# County of Fresno

Contract No. 23-29-C

**ADDENDUM NO. 1** to CSA 1 TAMARACK WATER INFRASTRUCTURE REPLACEMENT, revising the Bidding and Contract Documents as follows:

- NOTES:**
1. SEE DETAIL 5 ON SHEET CD-2 FOR MORE INFORMATION ON INSTALLATION.
  2. BOULDERS, TREES AND OTHER MISCELLANEOUS FEATURES NOT SHOWN FOR CLARITY.
  3. CONTRACTOR'S RESPONSIBILITY TO FIELD VERIFY LOCATION WHERE DITCH CROSSING IS NEEDED.

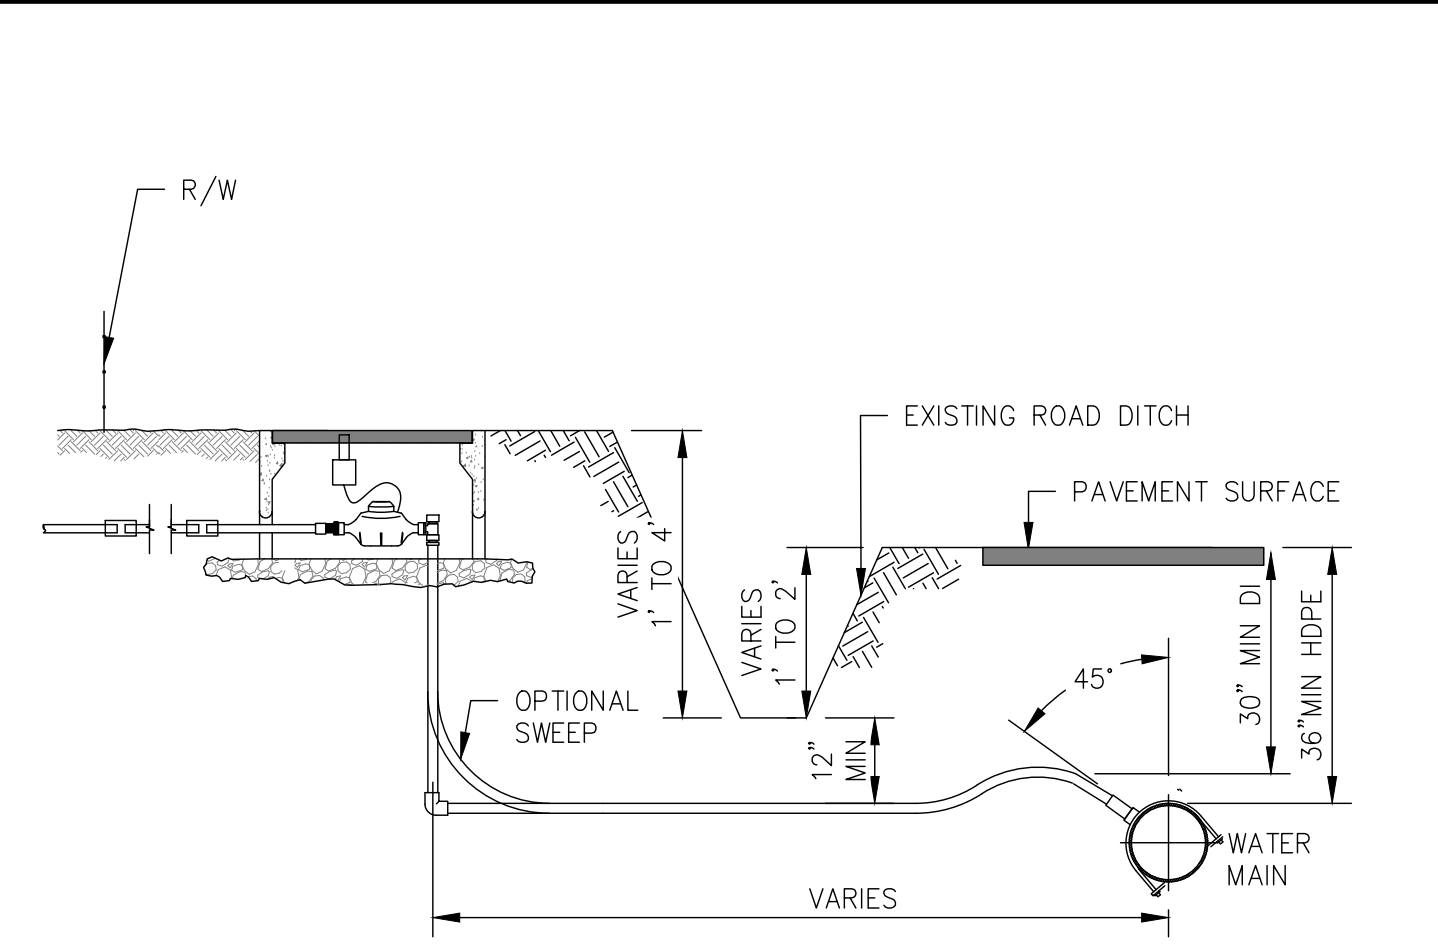
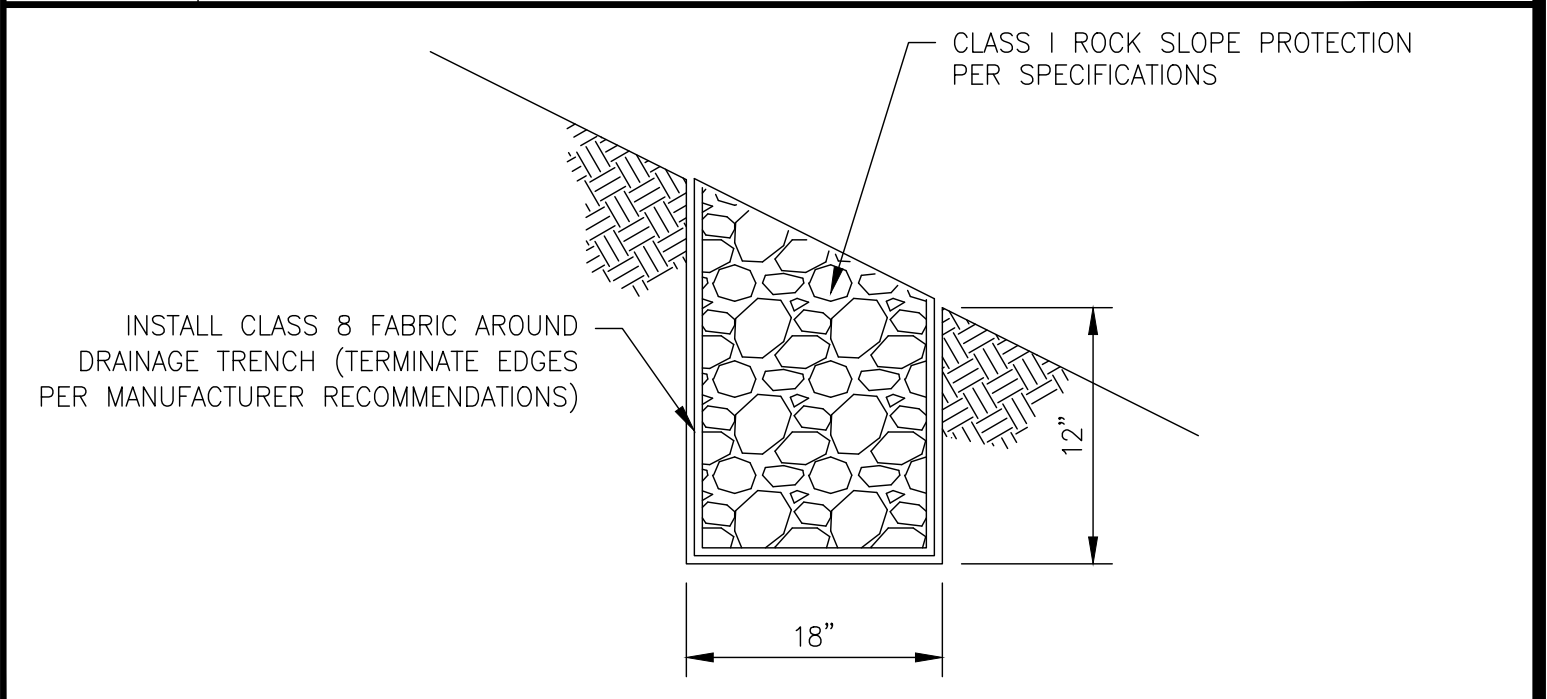
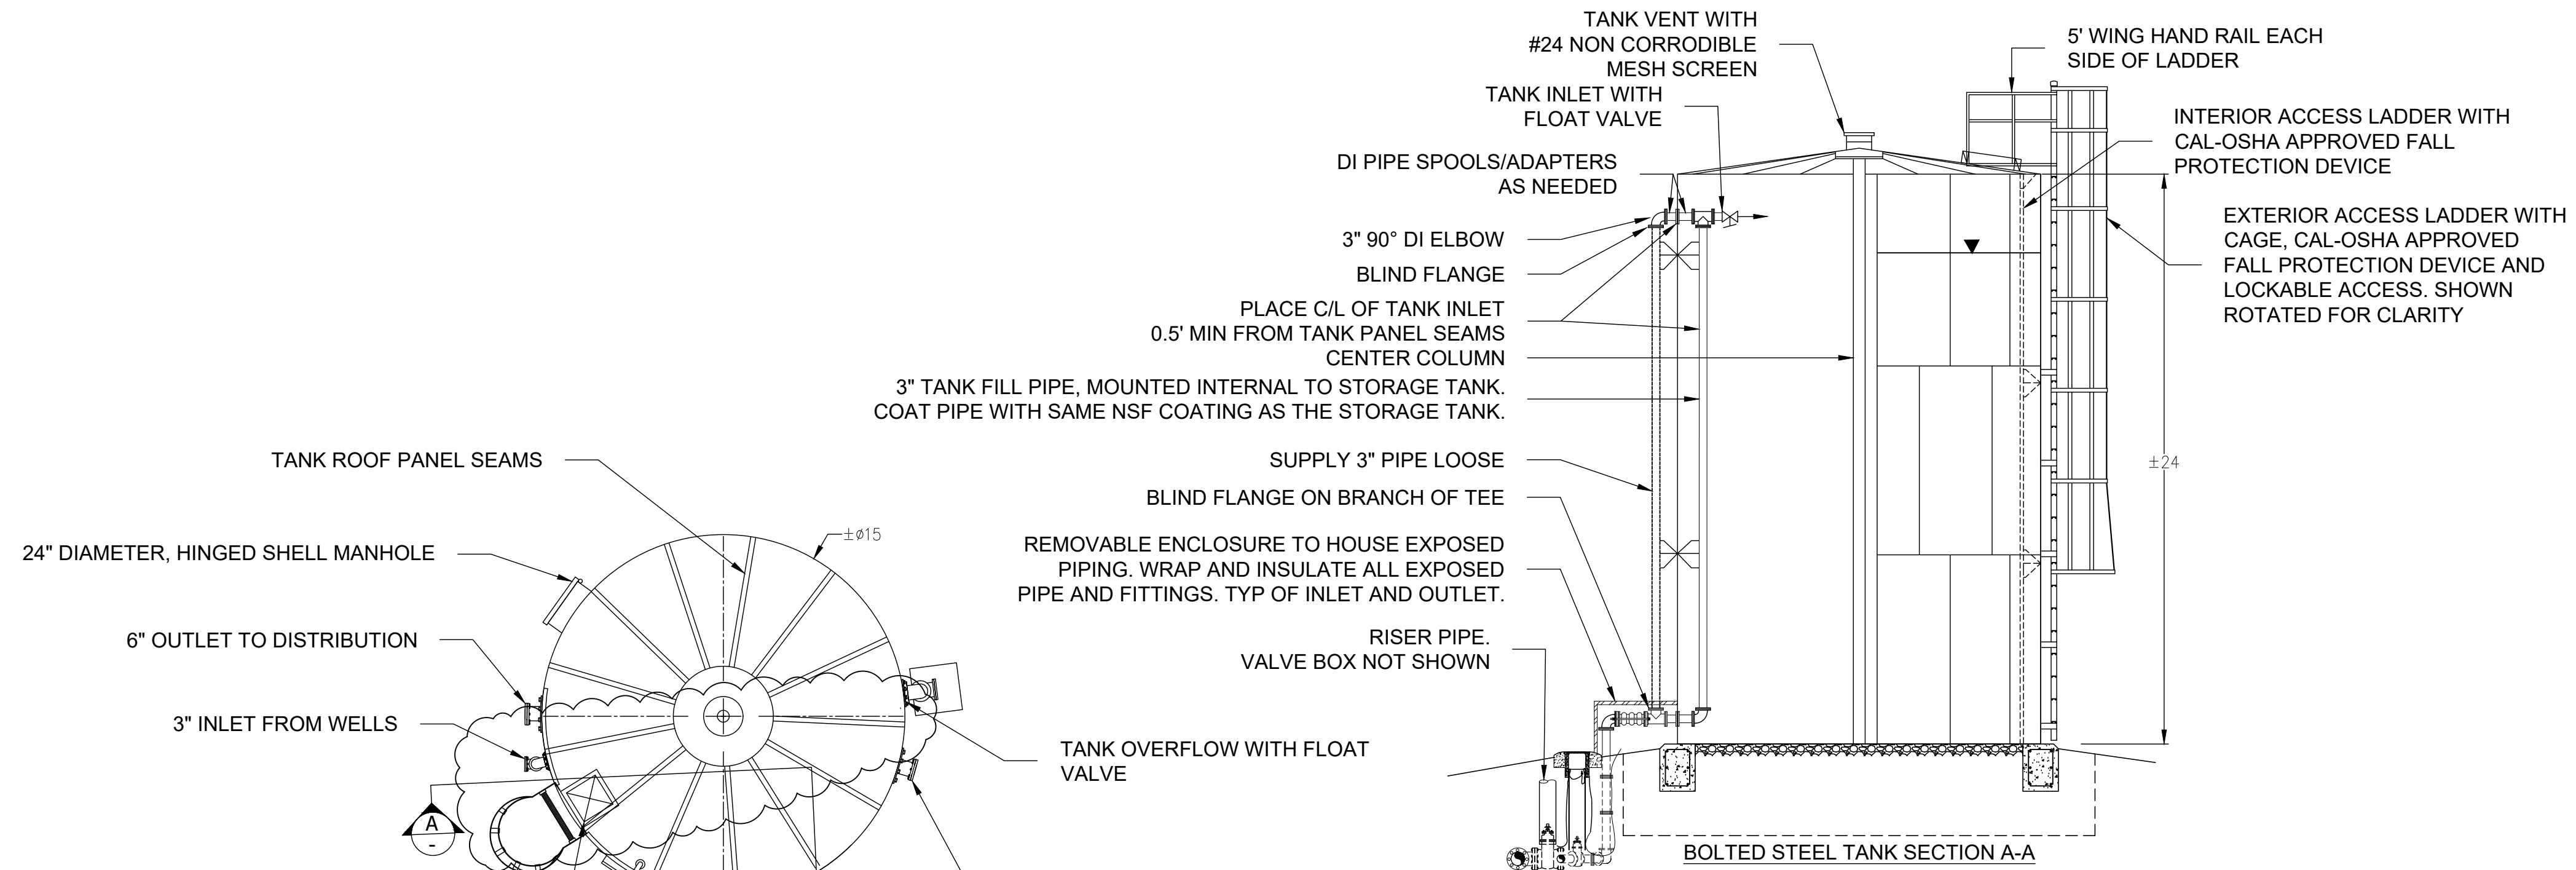
Changes to the following pages are denoted by a revision cloud.

Construction plan Sheet 18A

Construction plan Sheet 21

DEPARTMENT OF PUBLIC WORKS AND PLANNING  
**CONSTRUCTION DETAILS CD-6**  
 DRAWING NO. 11334 SHEET NO. 21A TOTAL 23

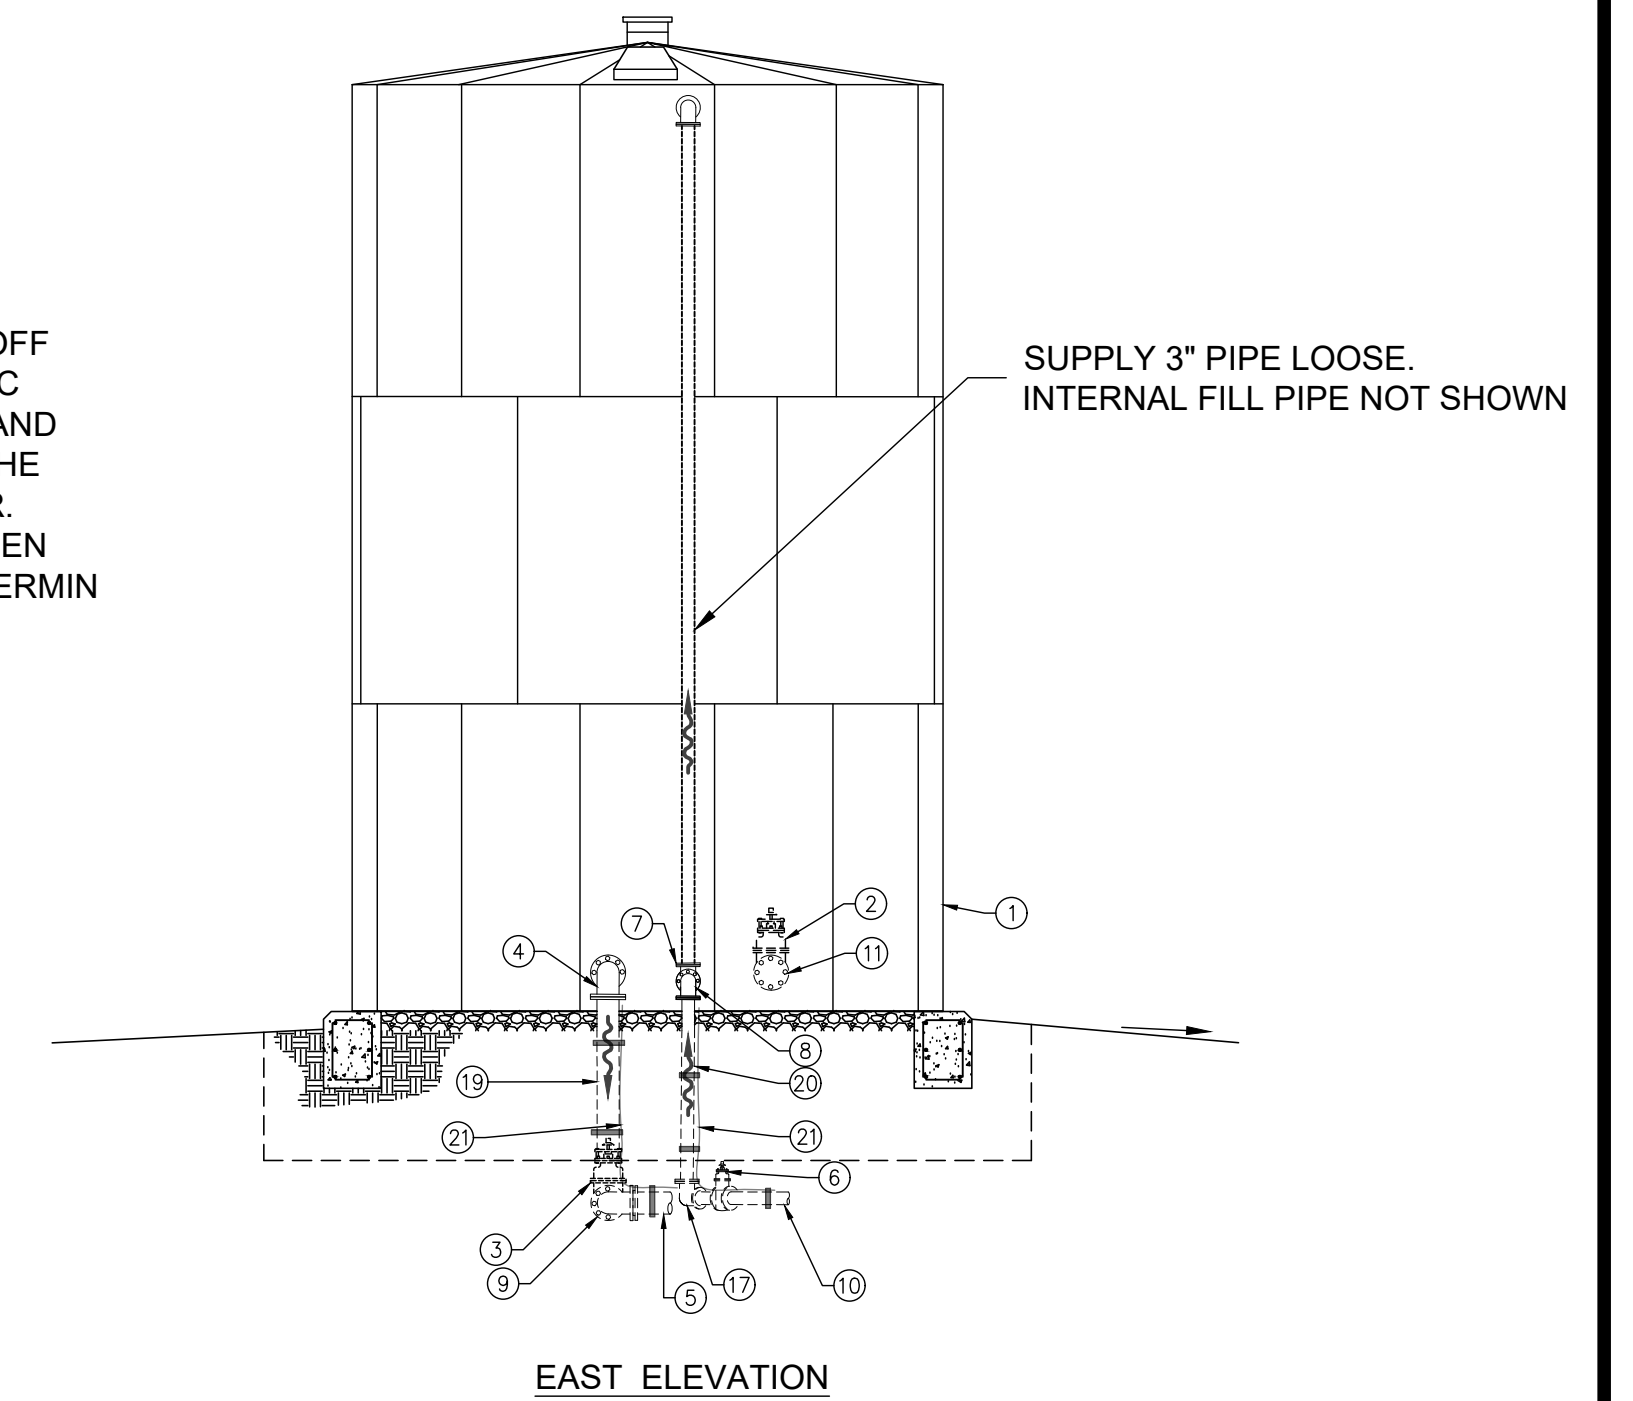
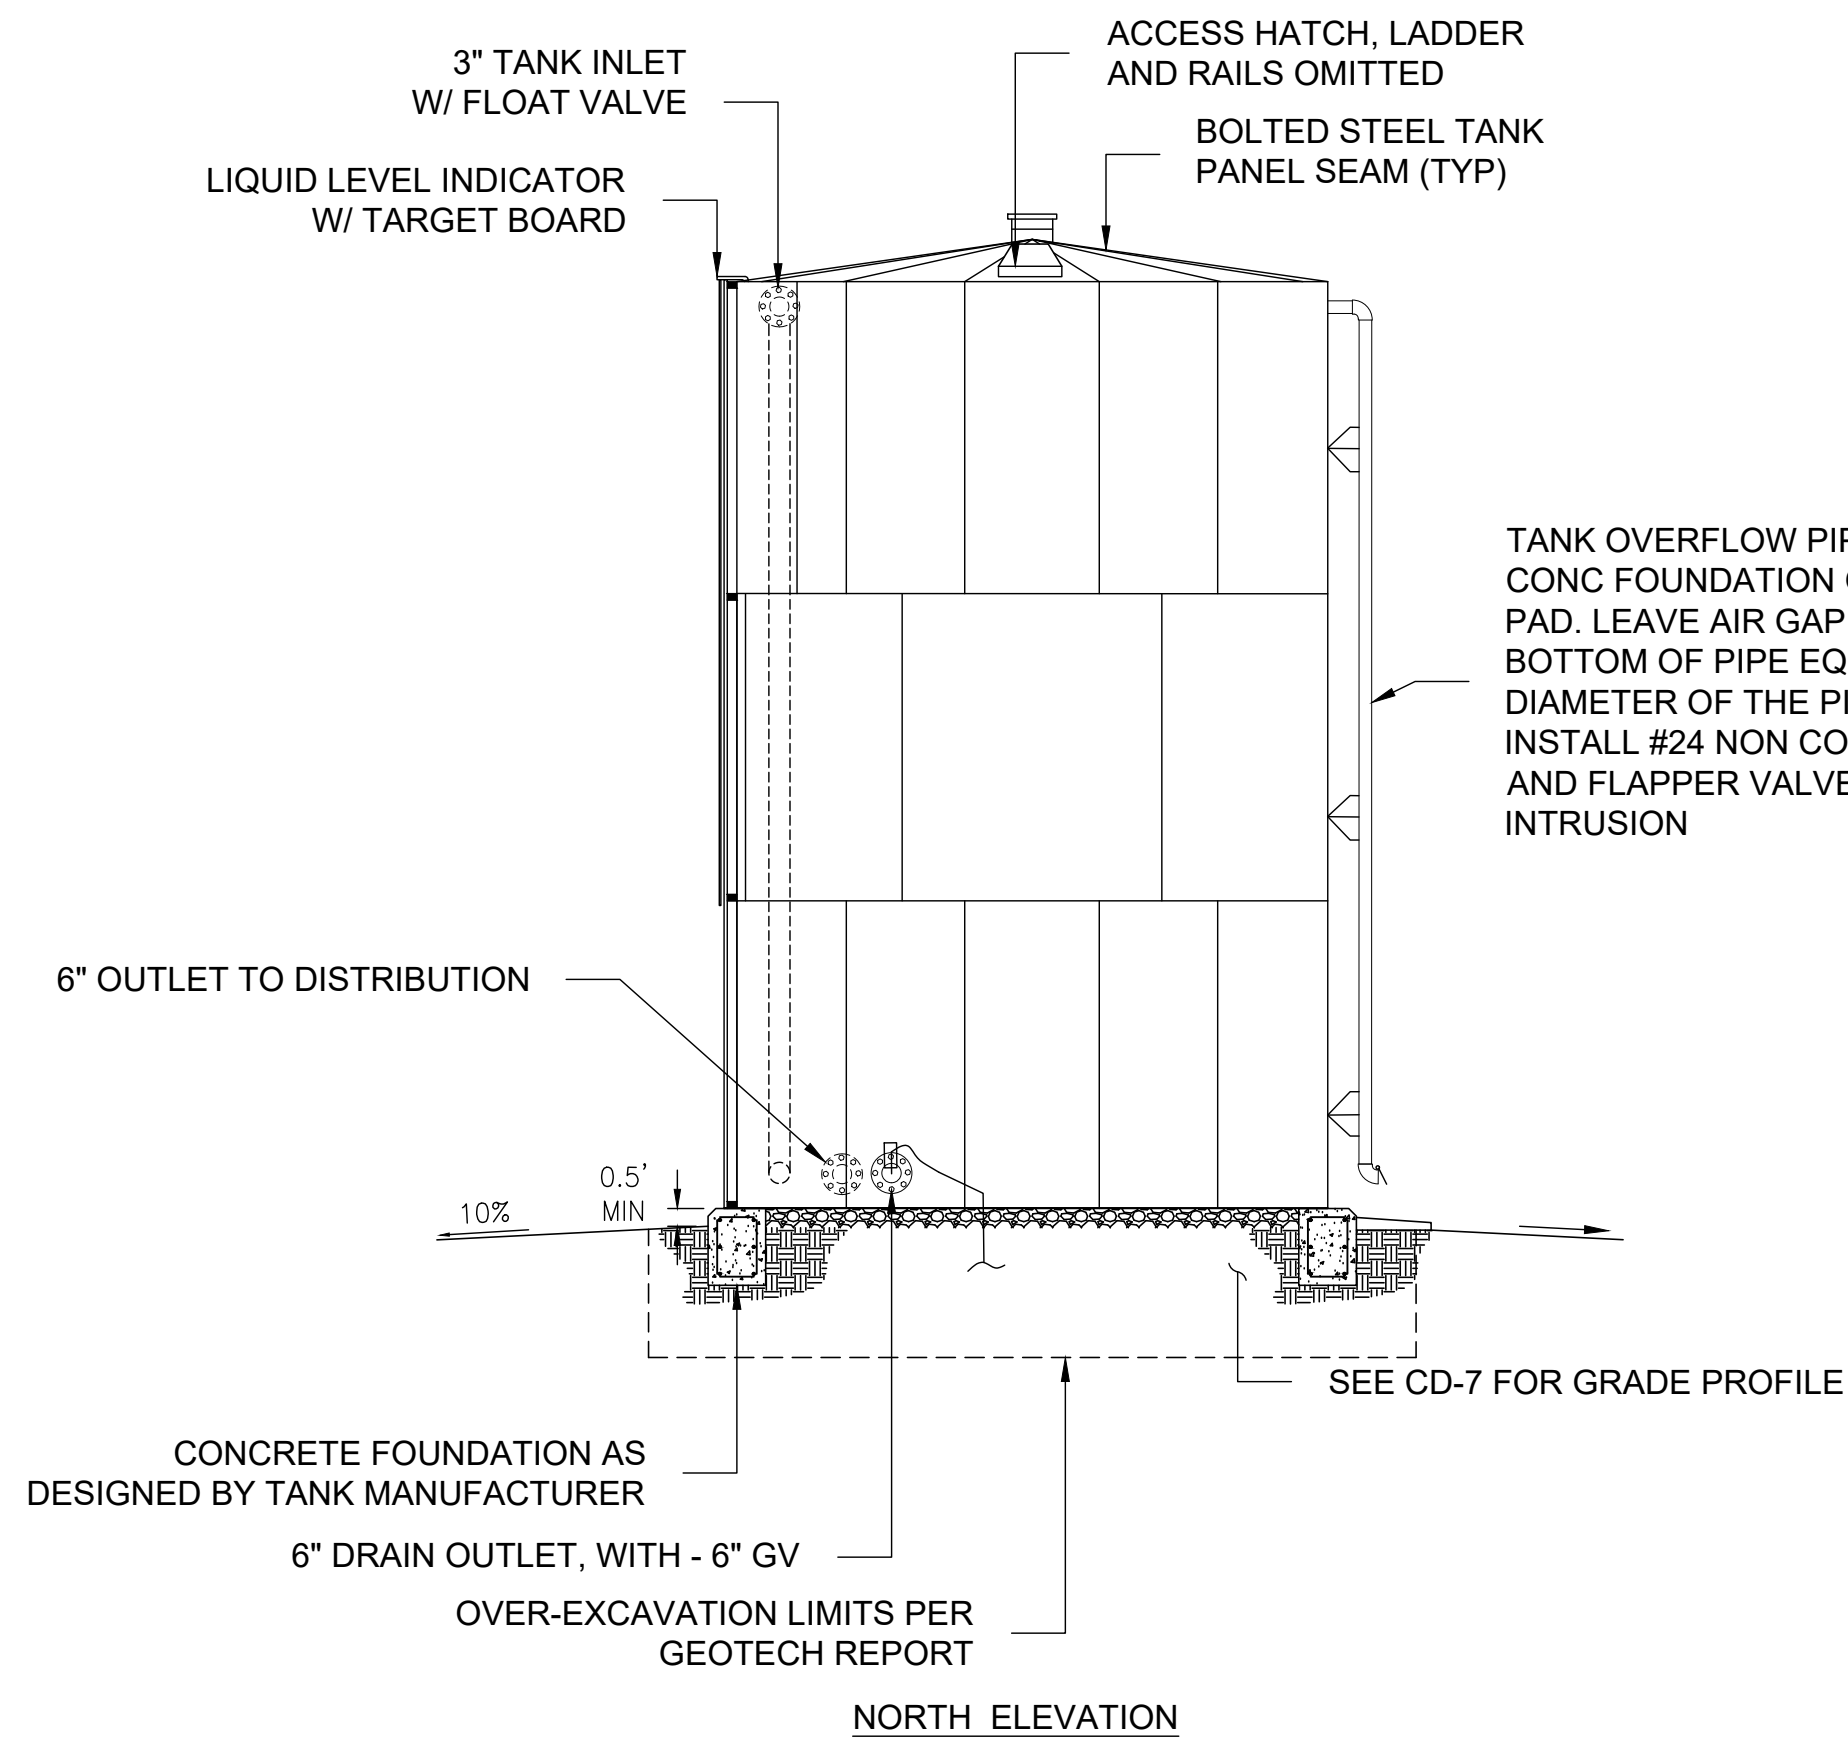
Construction plan Sheet 21A
